Optical Sub-Task Force budget proposals

IEEE P802.3ba, New Orleans, January 2010

Optical proposals for 40GBASE-LR4

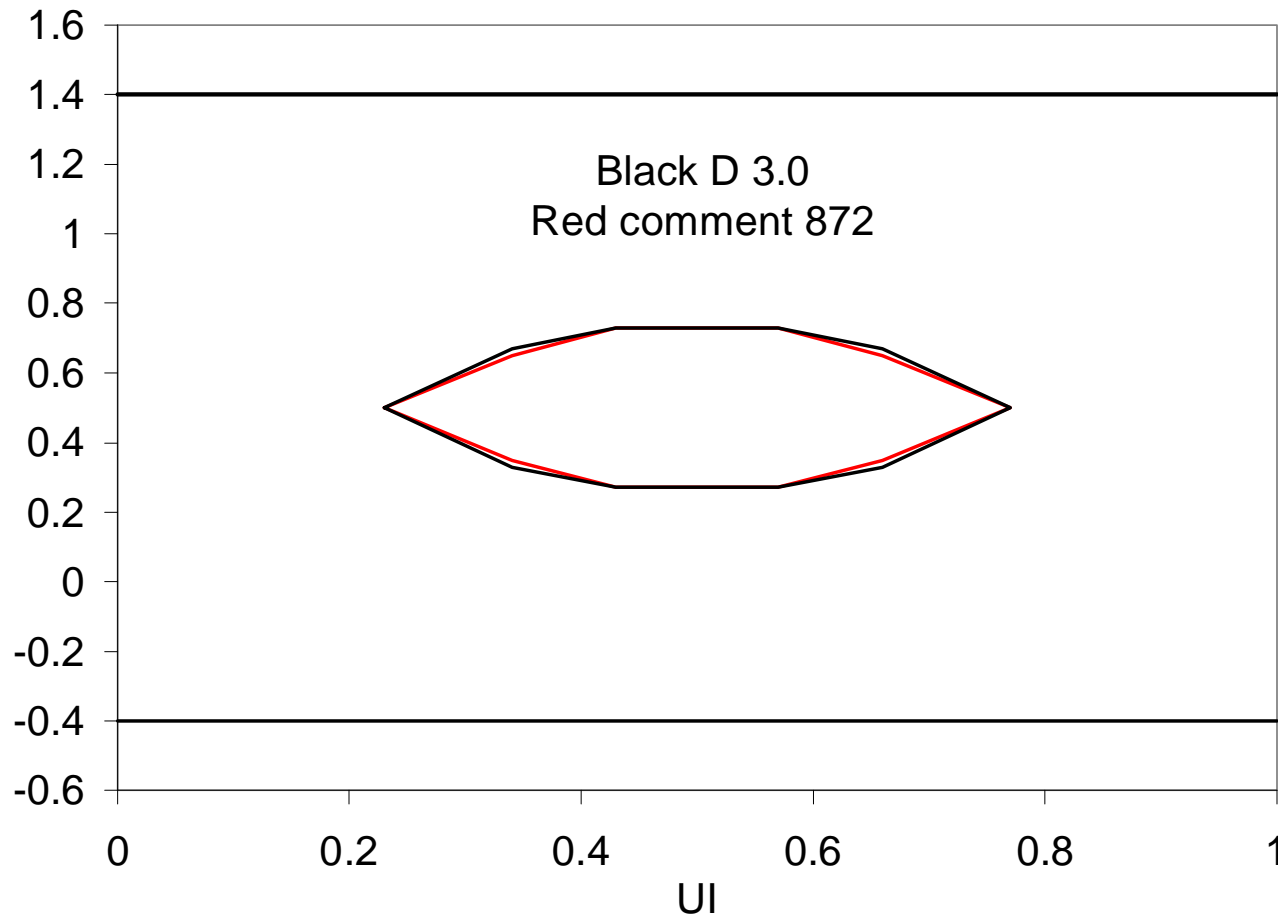
D 3.0	792	Agree
Table 87-7			
Total average launch power (max) dBm	8.3	8.6	
Average launch power, each lane (max) dBm	2.3	2.6	
Average launch power, each lane (min) dBm	-7	-6.7	
OMA each lane max dBm	3.5	3.8	
OMA each lane min dBm	-4	-3.7	
OMA –TDP each lane min dBm	-4.8	-4.5	
TDP each lane max dB	2.3	2.6	
RIN ₂₀ OMA (max) dB/Hz	-128	-130	
Table 87-8			
Damage threshold (min) dBm	3.3	3.6	
Average receive power, each lane (max) dBm	2.3	2.6	
Average receive power, each lane (min) dBm	-13.7	-13.4	
Receive power, each lane (OMA) (max) dBm	3.5	3.8	
Receiver sensitivity (OMA), each lane (max) dBm	-11.5	-11.5	
Stressed Rx sens OMA, each lane dBm	-9.9	-9.6	
Vertical eye closure penalty, each lane dB	1.6	1.9

Insertion loss limits of mated HCB-MCB

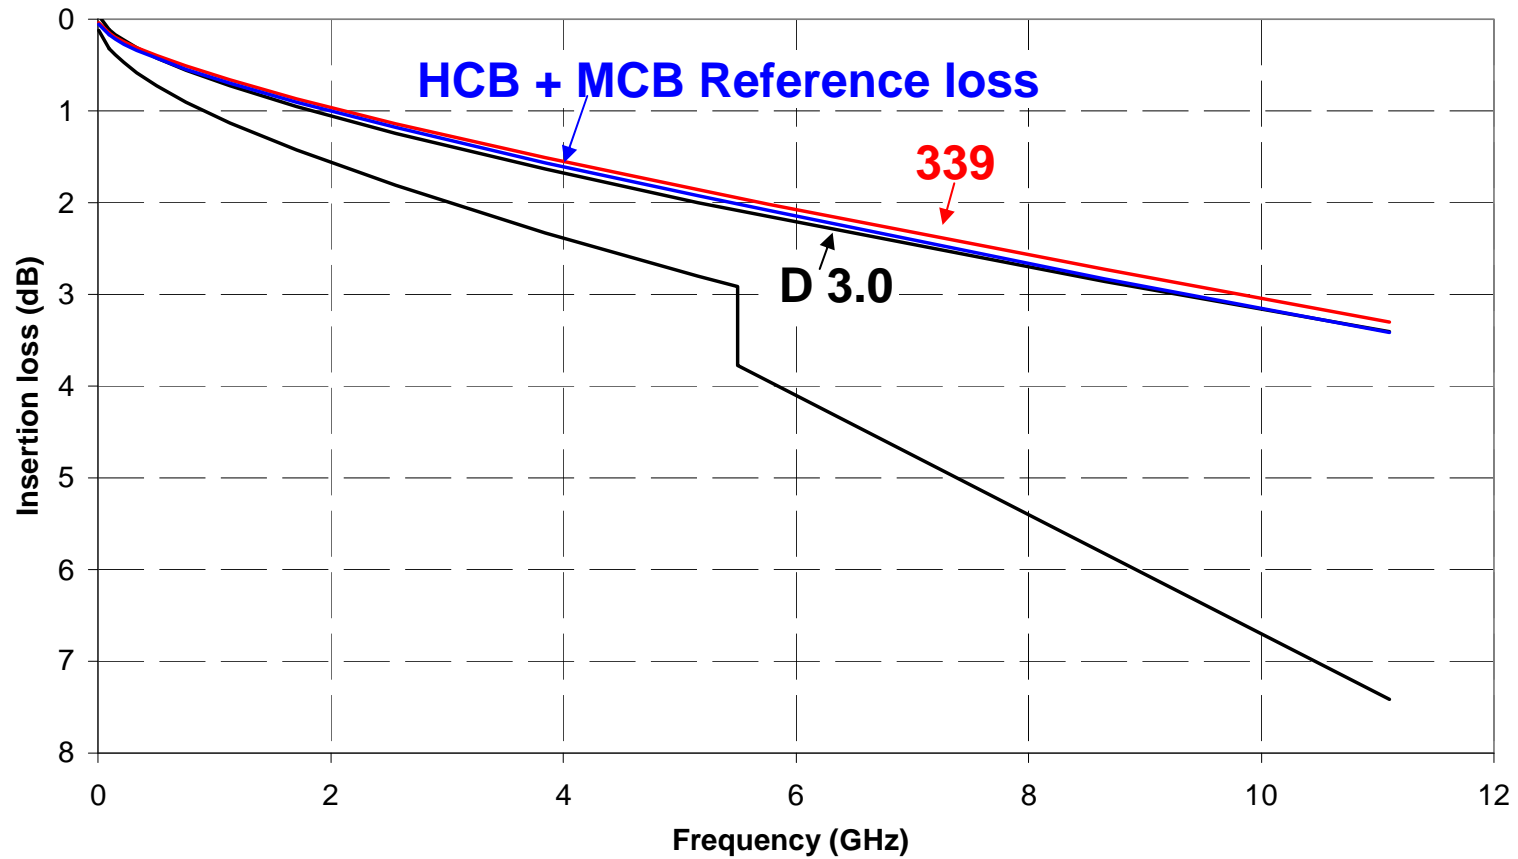
This proposed change also applies to Equation 85-35
